Environmental
Protection Agency

August 4, 2011

Re: Cobbleton Grove Condominiums / Franklin County

This letter is written regarding the storm water inspection that I conducted at Cobbleton Grove Condominiums, located along Ebright Road, in Franklin County, on July 28, 2011. I understand that these construction activities are covered under the General Storm Water Permit Associated with Construction Activities. Based on my site inspection and the General Storm Water Permit, the following items must be addressed:

Cobbleton Grove Condos
Install & maintain erosion controls
Sediment on streets
Blacklick Creek Watershed
July 28, 2011
Photo by Greg Sanders

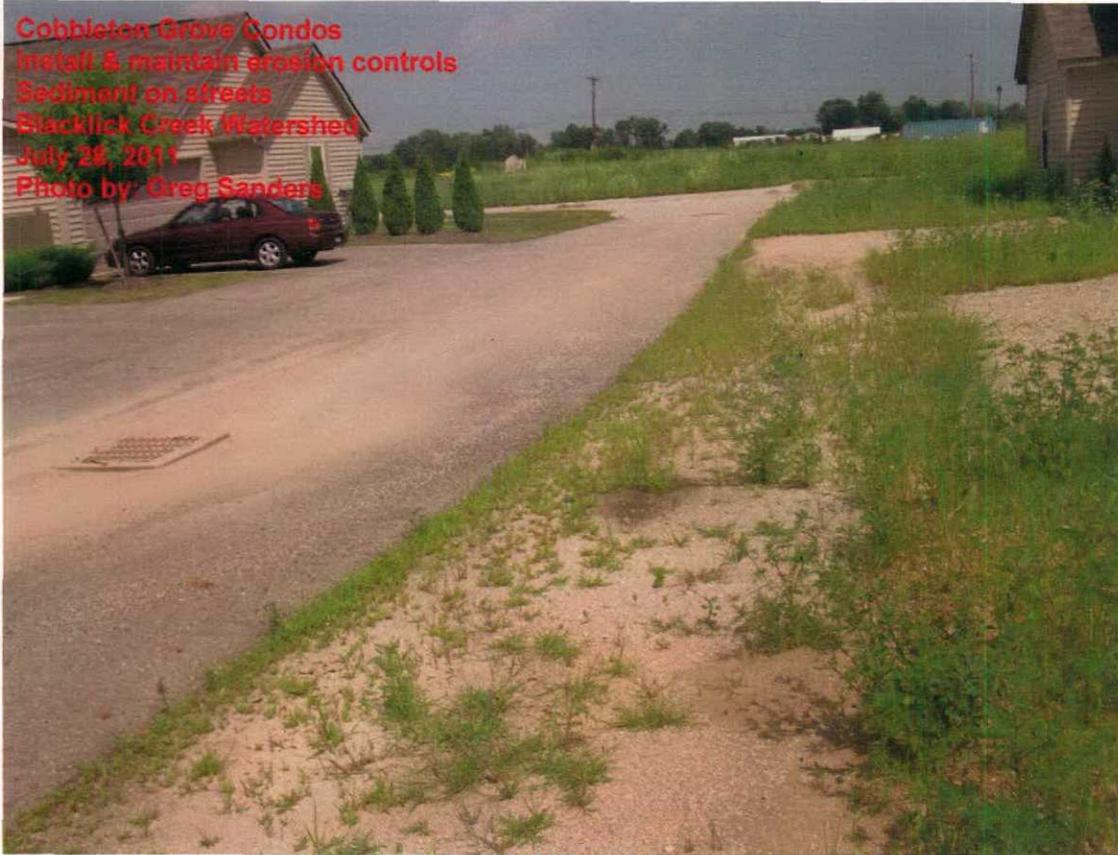
There appeared to be construction activity at the site. Sediment was discharging on to the streets and to the storm water drains. Straw waddles and/or silt fence is needed around the barren areas to prevent run-off. Dandy bags need to be installed and maintained on the storm water drains. Please see attached pictures.

Please be aware that the General Permit mandates that all barren areas which remain idle areas in excess of 21 days be protected from erosion (i.e., seed and straw), within seven days from the last construction activity.
